St. Louis Site Expert Geohydrologic Panel

October 5, 1995

QUESTIONS/ACTIONS AND RESPONSES FROM
ST. LOUIS EXPERT PANEL MEETING
SEPTEMBER 15, 1995

POTENTIOMETRIC SURFACE OF THE UPPER GROUNDWATER SYSTEM

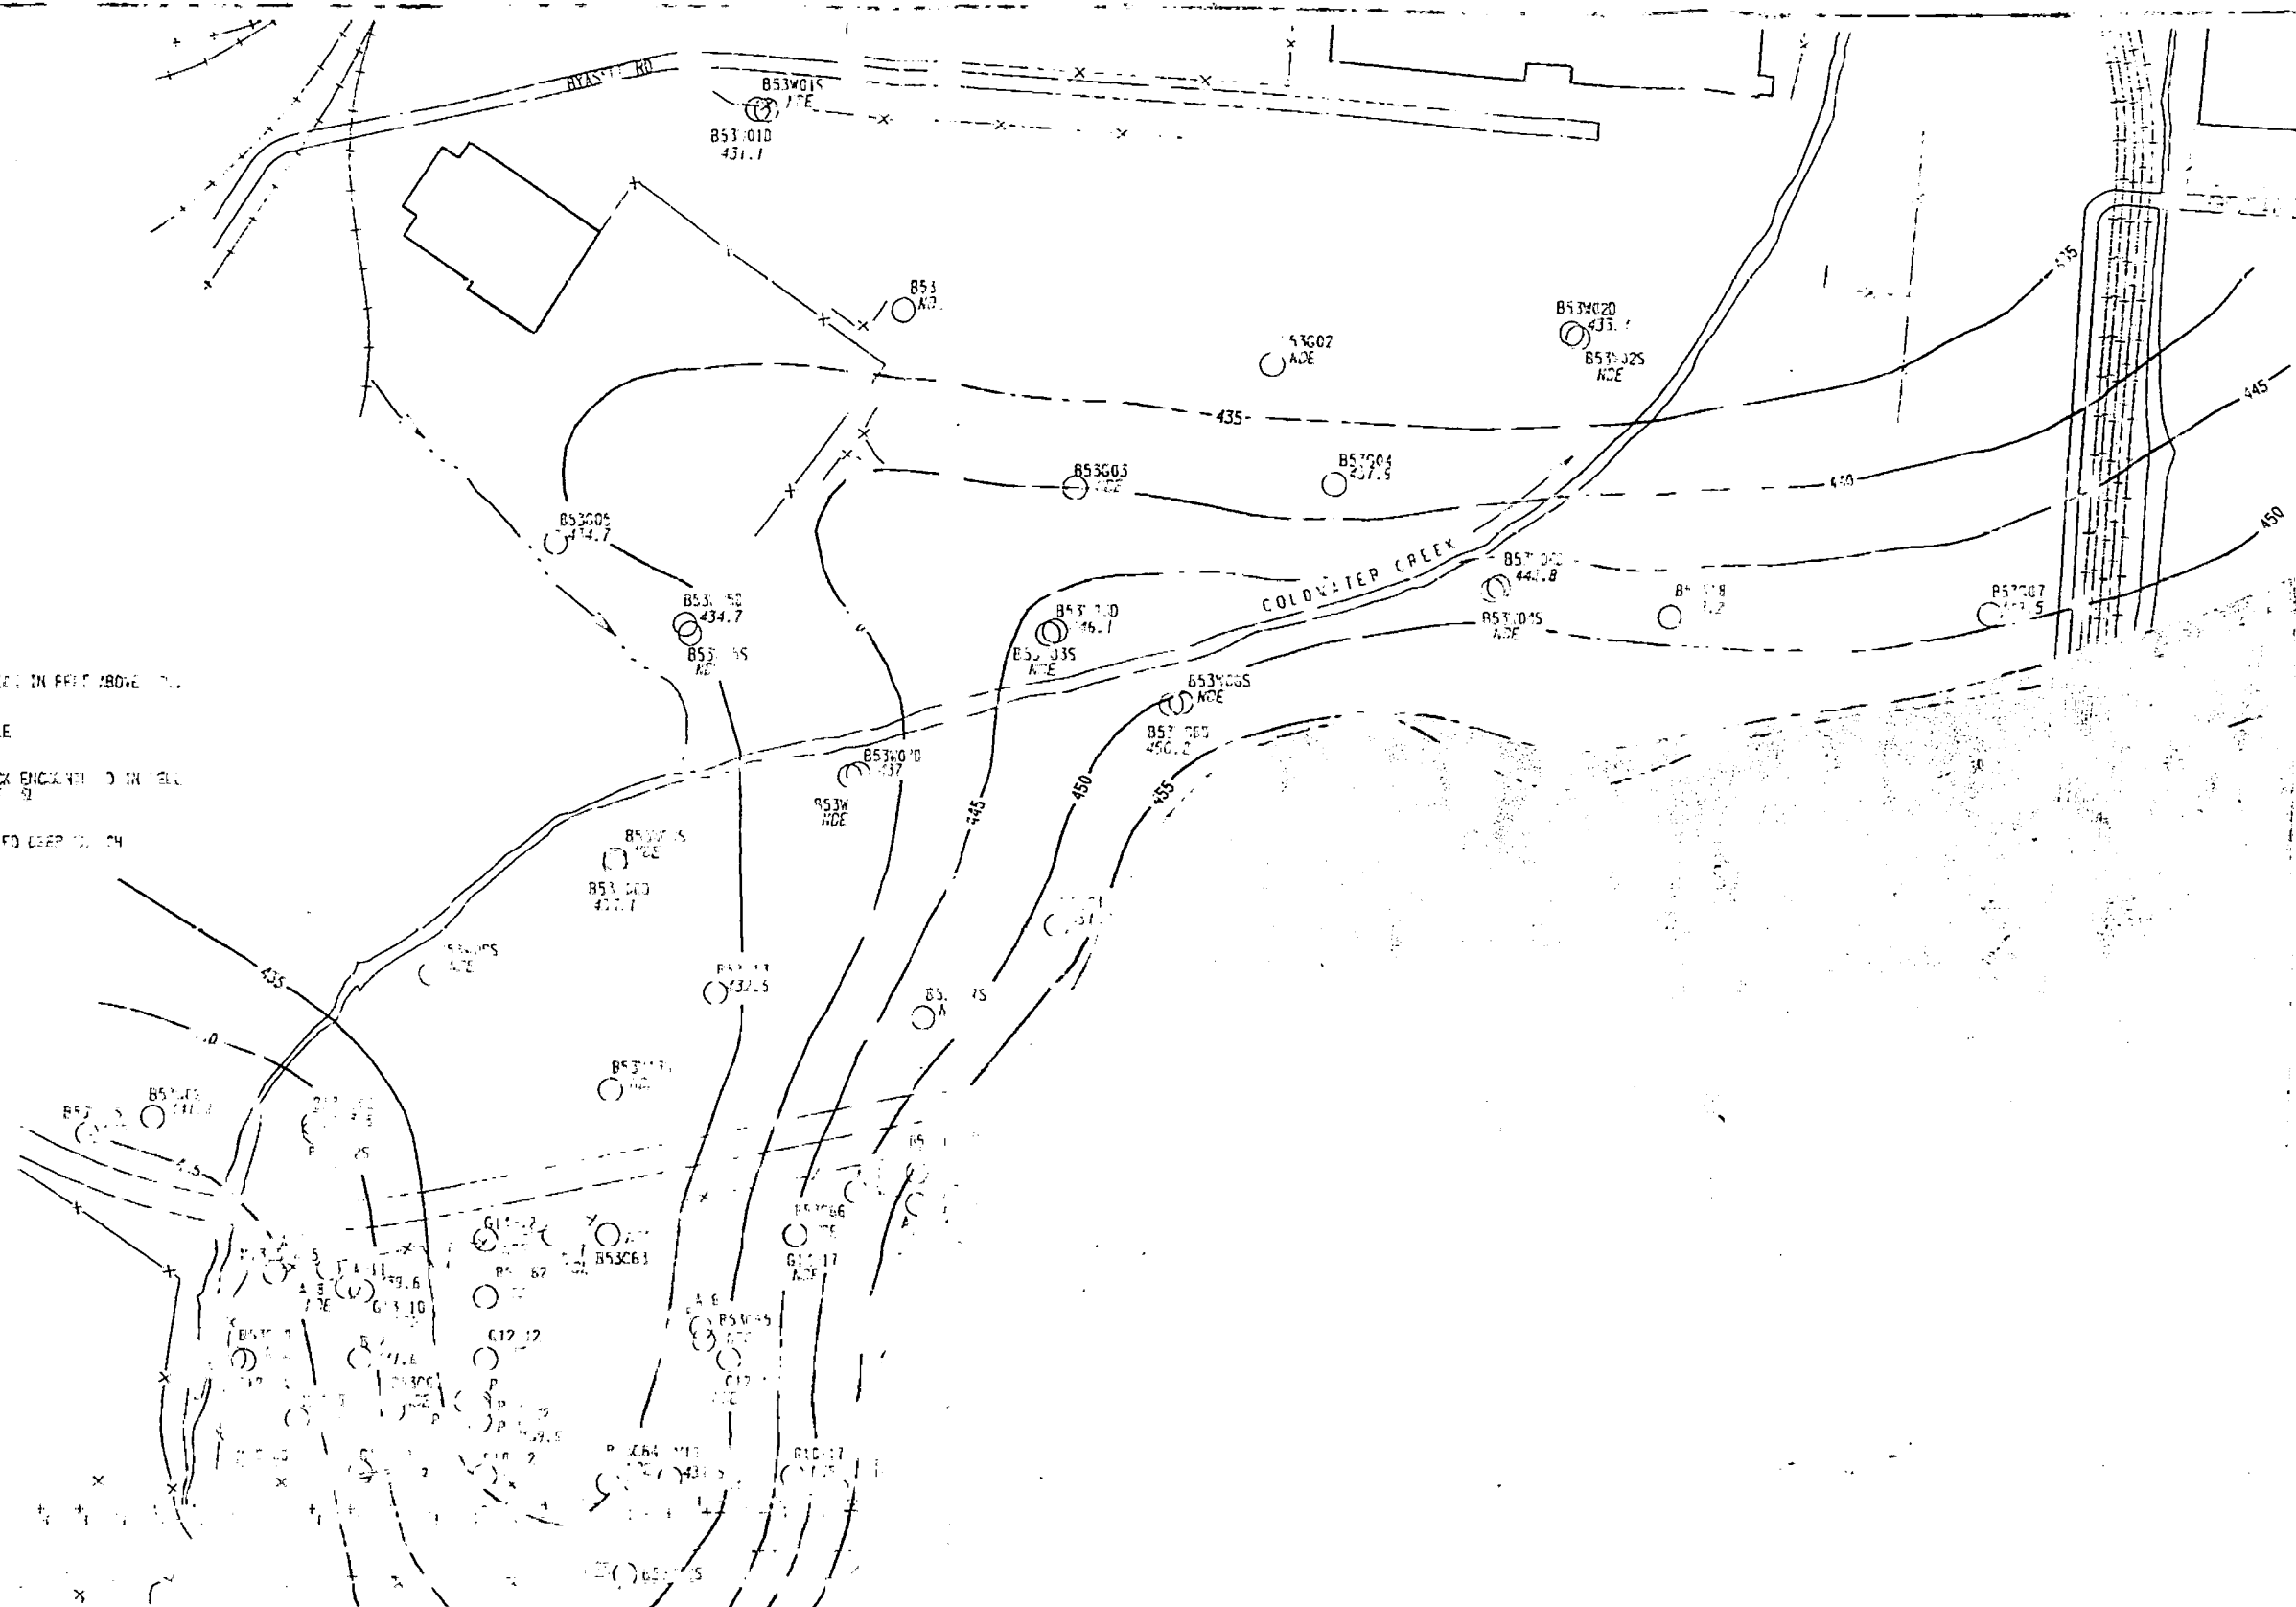
- 14) Depict the range of water table data and potentiometric map/contouring. (ALEY)

Provided during last meeting. Additional data available in Site Suitability Report.

SLAPS FILL DESCRIPTION MAP

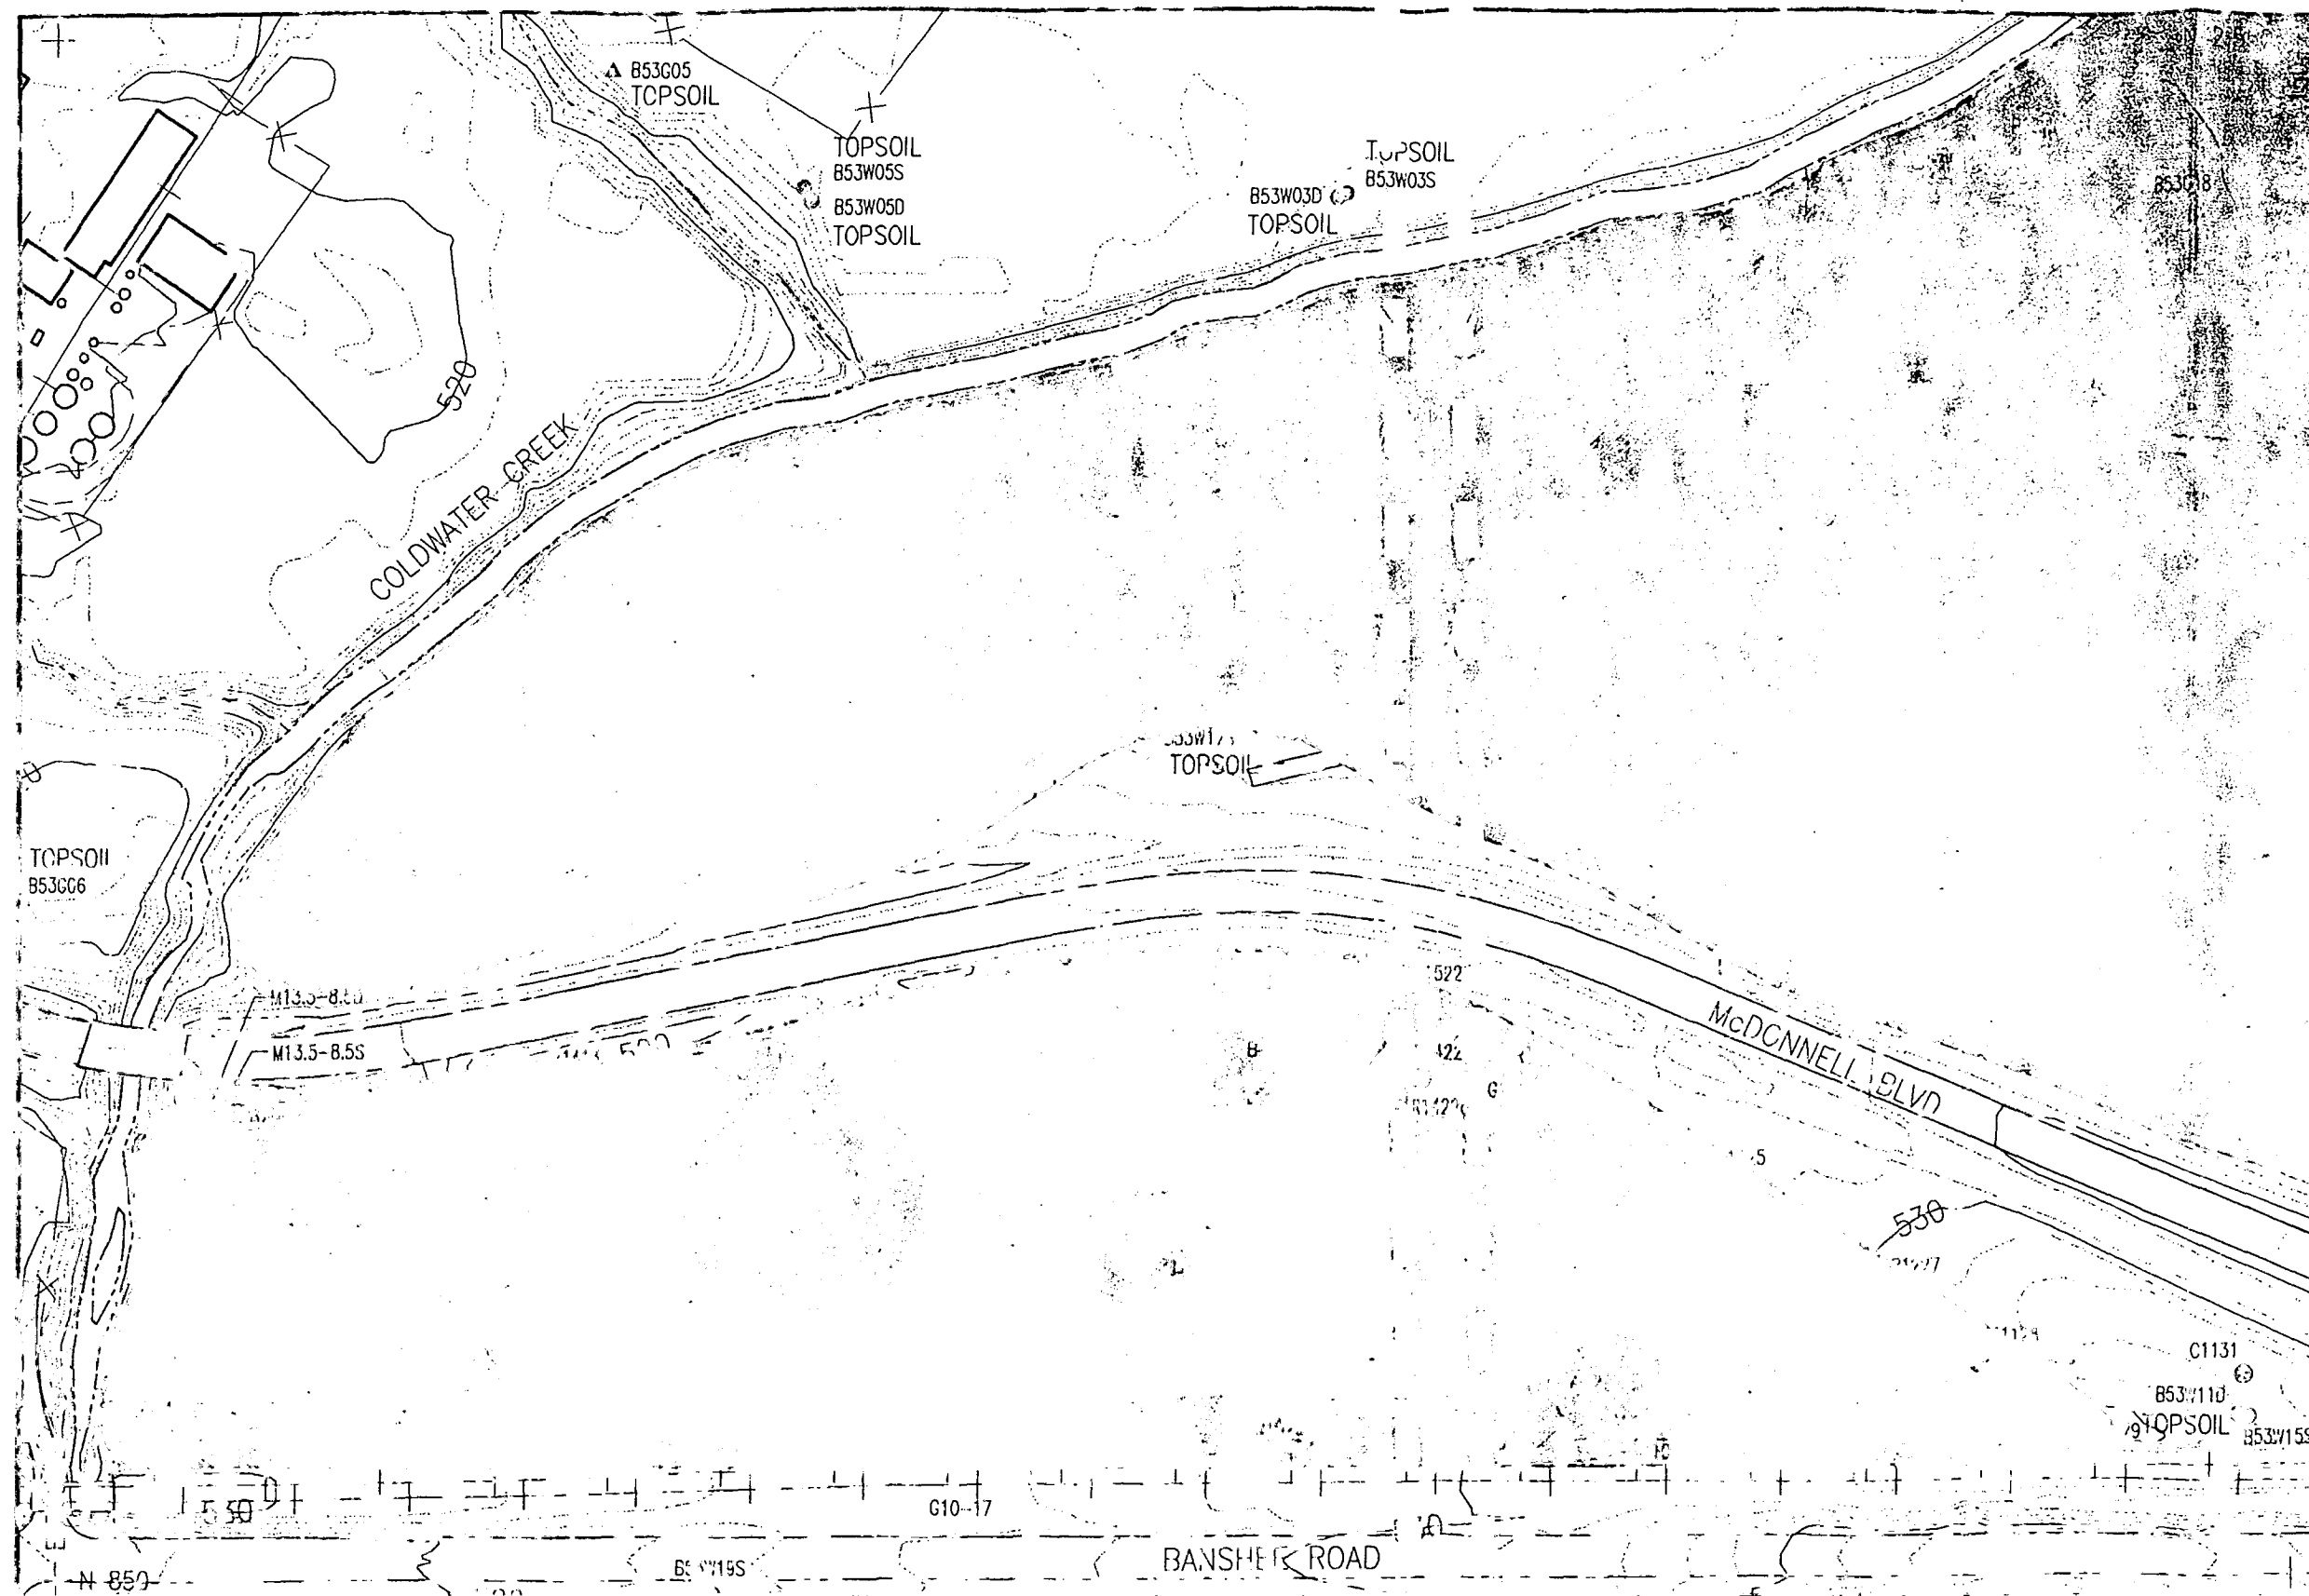
- 5) Were any of the fills brought to SLAPS of low permeability? (ALEY)

Response: The source of the fill could not be determined. A map of the fill texture was constructed based on the geologic log made during the drilling of each borehole. That map is provided. Also included are isopach maps of the estimated fill thickness.
